From: North America Product Management  
 To: Wholesale and OEM Customers  
 Date: May 29, 2019 (replaces April 12, 2019 bulletin)  
 Subject: AJ Electrical Box Potential Miswiring

## REVISED PRODUCT BULLETIN

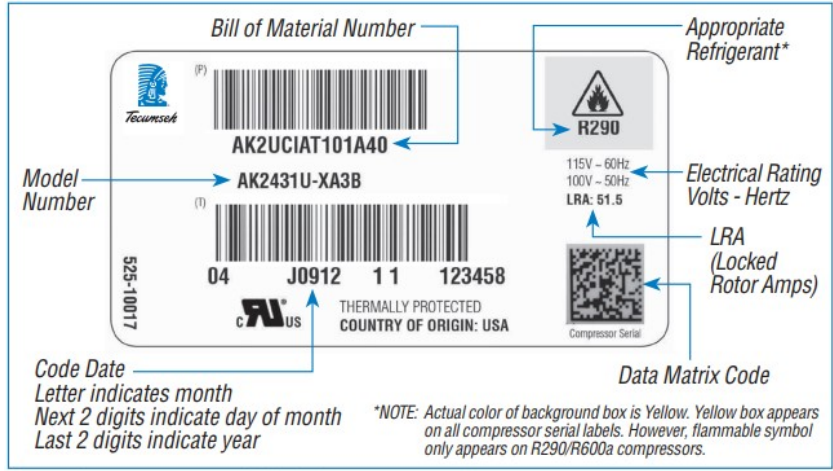
Tecumseh has identified a potential issue with relay wiring in specific AJ electrical boxes. All AJ compressor items (shown below) utilizing the AE1170-\*\*\*\* electrical boxes have been or should be placed on hold pending evaluation and/or correction for any product date code (serial number) 1/1/2019 or later (through 3/30/19). The asterisk signifies different variants of the AE1170 electrical boxes.
